Addendum Number	Issue Date
3	January 29, 2019
Project	Project Number
SBC#373/003-12-2018	Genesis 18-035.03
APSU Dunn Center Lighting Replacement

The following items reflect modifications made to the Bid Documents for the above referenced project dated 08 January 2019.

LIGHTING RCP

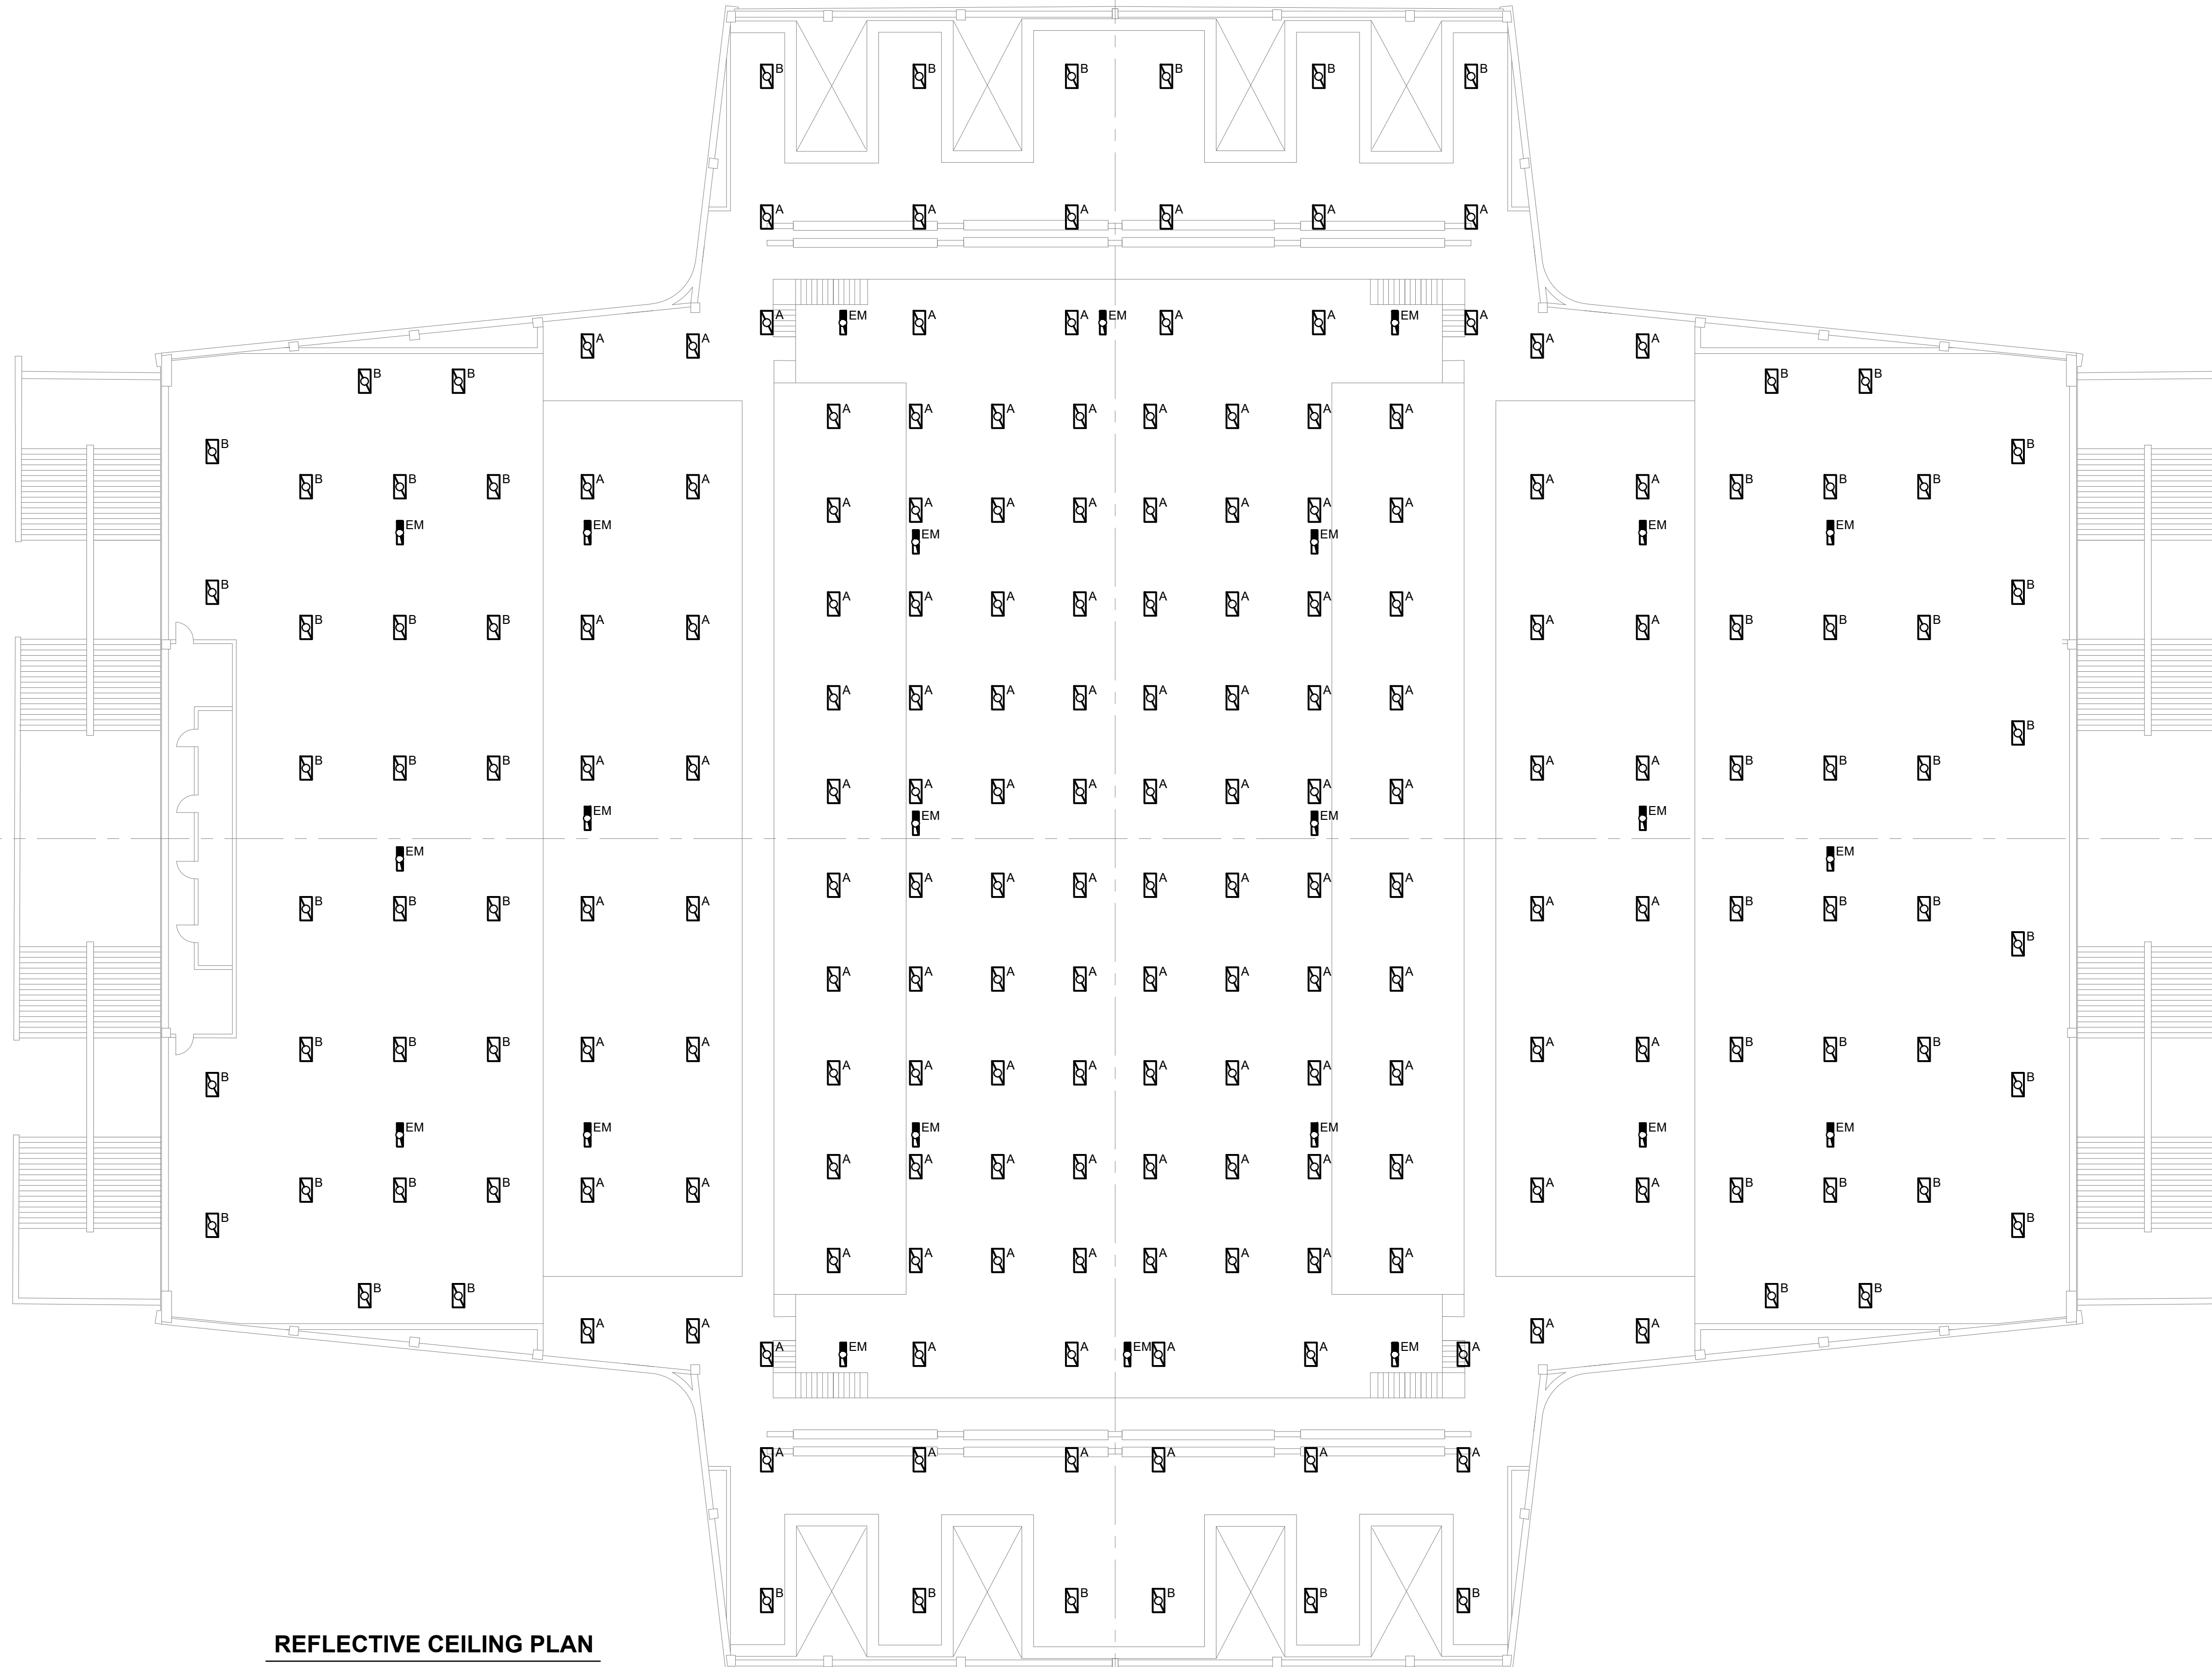
- E-100 LIGHTING RCP**
Revised drawing to include Addendum #2 revisions
